Received at CPC Hearing 5/9/19
D. Winslow

Proposed project changes in exchange for withdrawal of Discretionary Reviews by all parties.

2758 FILBERT STREET
SAN FRANCISCO, CA 94123

PROPOSED FIRST FLOOR PLAN

p. 35. Graphic:
This guideline strongly supports the position that the west side yard/light well area should remain open as specifically directed by the RDAT in its letter to the Project Sponsors' architect. (Exhibit 1) and in the Cow Hollow letters (Exhibit 2)

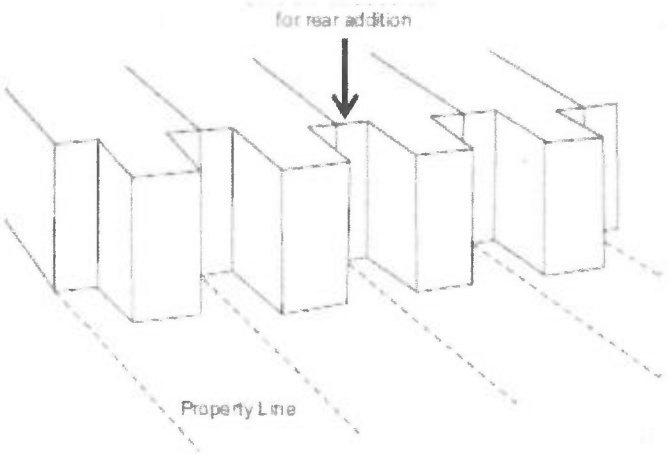
"*Expansions should be designed to avoid overshadowing neighboring gardens, existing sunlit decks, sunny yard space, or blocking significant views*", p.33. *"In attached homes in Cow Hollow, the lack of side yards limits light by residences and limits the sight lines around the residences. For this reason, attached homes are particularly vulnerable to deprivation of light and air by a neighboring rear expansion. Therefore, it is particularly important in attached homes that the rear additions be set back at their sides as much as necessary to preserve the existing extent of light and air to adjacent structures, as shown in the following figure."*

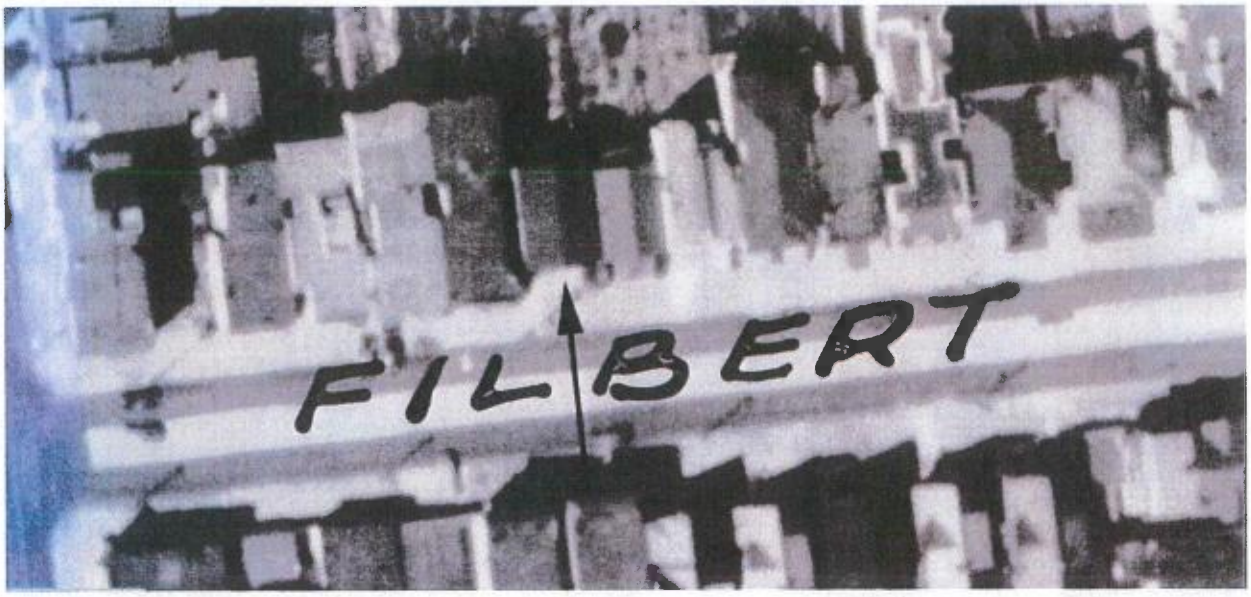
As is evident from the Sanborn Map and photo, (Exhibit 6) there is a historic setback between the existing buildings that allows light, air and privacy for the neighbors. As set forth above and detained in the floor plans, the project Sponsor ignored the directives from the RDAT Memo and plans to fill in the entire setback on each floor. This should not be tolerated.

DEMO CALCULATIONS SUMMARY

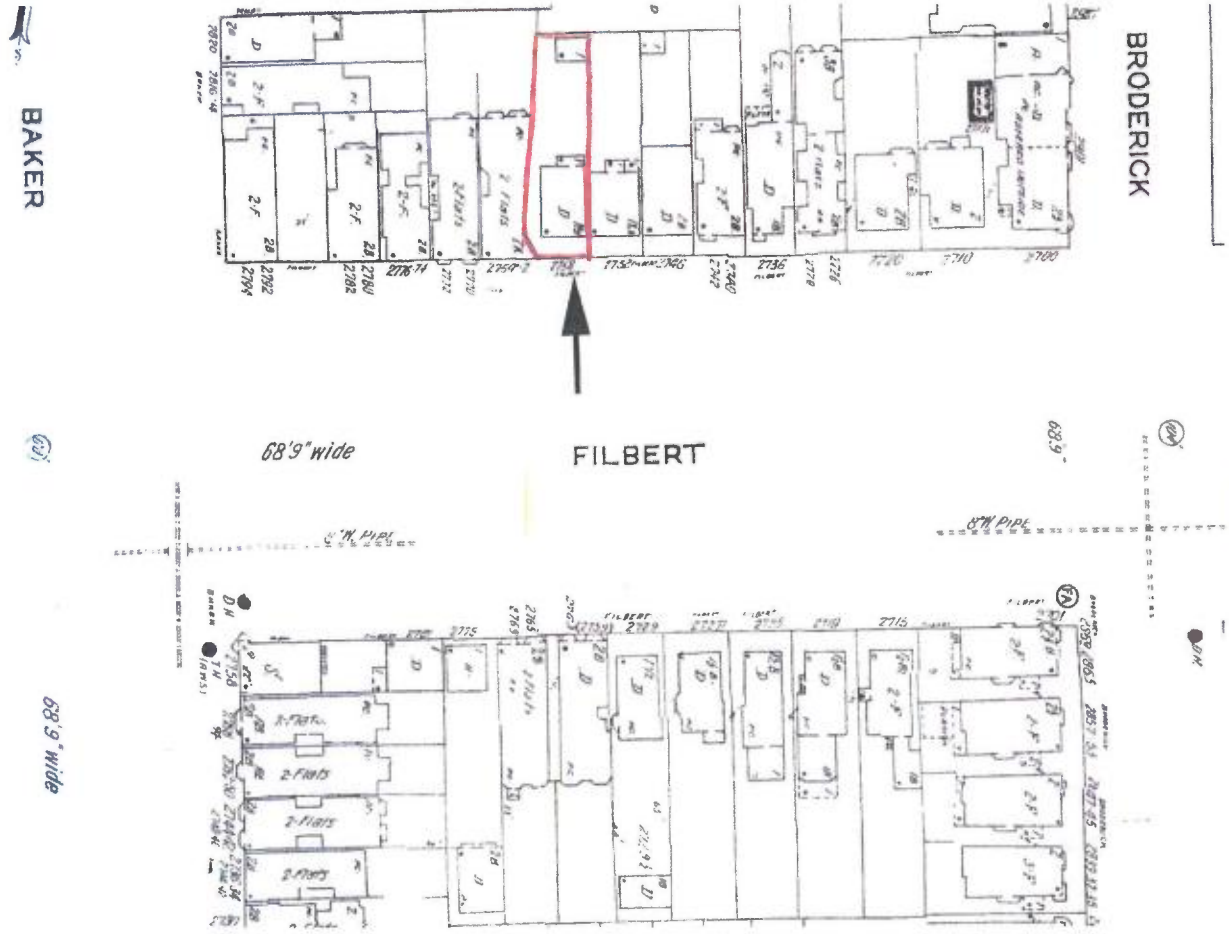
The Project calls for the complete demolition of the front and rear façade, every floor of the structure will be demolished. ALL interior walls, supports, partitions, floors, ceilings and the roof are to be removed100%. The ONLY portion of the building to allegedly remain is a portion of the blind east side wall flush to the eastern neighbor and a smaller blind portion of the west side wall which is somehow now to become an *internal* wall. Attached hereto as Exhibit 7 are copies of the demolition floor plans outlined in red the walls and elements to be removed. The Project completely "guts" the existing building…removes 100% of the front and rear façades and most of the west and east facades as well as 100% of the interior walls, floors, ceilings and all other elements. How on earth does the Project NOT qualify as a demolition? Section 317(b) (2) states:

Obviously the price point on the building places it out of the "affordable" housing range, but there are no calculations or explanations as to how the Project avoids evaluation as a demolition, given the removal of the 100% of the rear and front façade, a complete reconstruction from the ground up and removal of nearly every interior element that makes up the building including all the foundations, all floors, ceilings and the roof.

This Project appears to be a demolition, the Sponsors should be required to address that issue. The Sponsor has not complied with the Planning Department Requirements sent by the RDAT in January 2018, and the "alteration" is still out of character and completely out of place in this neighborhood. A demolition permit should be given the mandatory public notice and that the project be altered to comply with the Cow Hollow Design Guidelines (not applied by the Dept) and redesigned to satisfy the requirements the Dept outlined in its Memo to the sponsors' architect.
